TRANS/WP.29/2000/23/Rev.1  
20 April 2000

#### PROPOSAL FOR DRAFT SUPPLEMENT 1 TO REGULATION No. 107

(Double-deck large passenger vehicles)

#### Revision 1

**"5.7.4. Access to escape hatches**

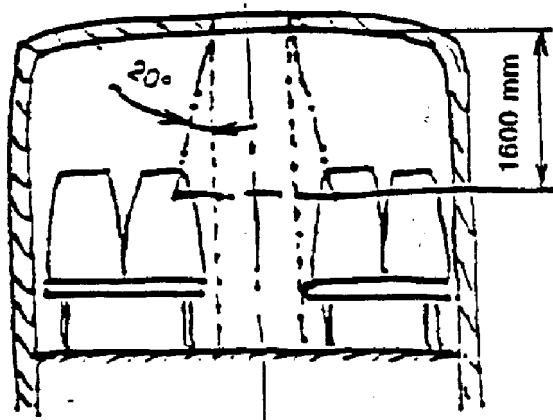
Paragraph 5.7.4., amend to read:

- 5.7.4.1. If one or more escape hatches are fitted in the roof, at least one escape hatch shall be located such that a four-sided truncated pyramid having a side angle of  $20^\circ$  and a height of 1,600 mm touches part of a seat or equivalent support. The axis of the pyramid shall be vertical and its smaller section shall contact the aperture area of the escape hatch. Supports may be foldable or movable provided they can be locked in their position of use. This position shall be taken for verification.

- 5.7.4.2. When the structural thickness of the roof is more than 150 mm, the smaller section of the pyramid shall contact the aperture area of the escape hatch at the level of the outside surface of the roof."

Figure 11

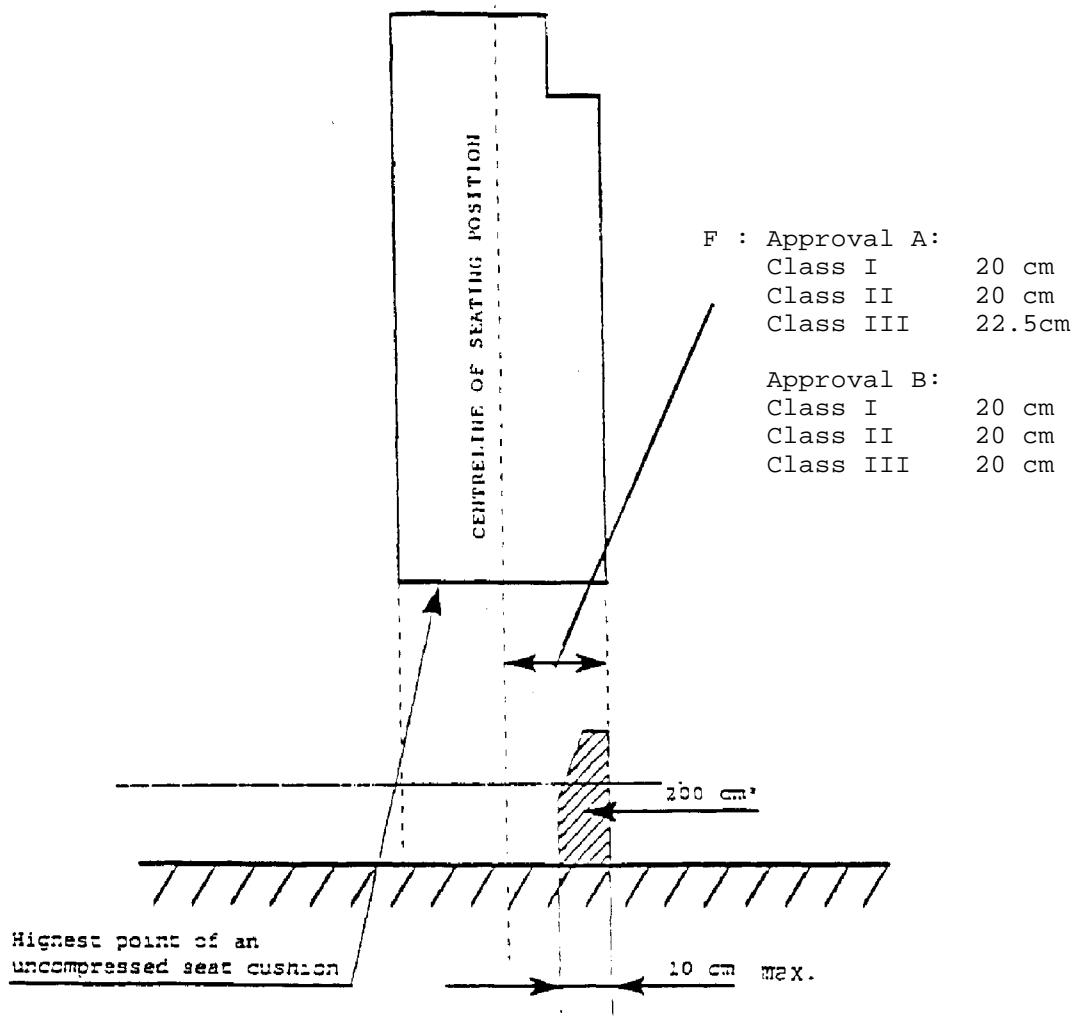
Annex 3, figure 11, replace by the following figure:

PERMITTED INTRUSION IN LOWER PART OF PASSENGER SPACE  
(See paragraph 5.7.9.6.2.3.)
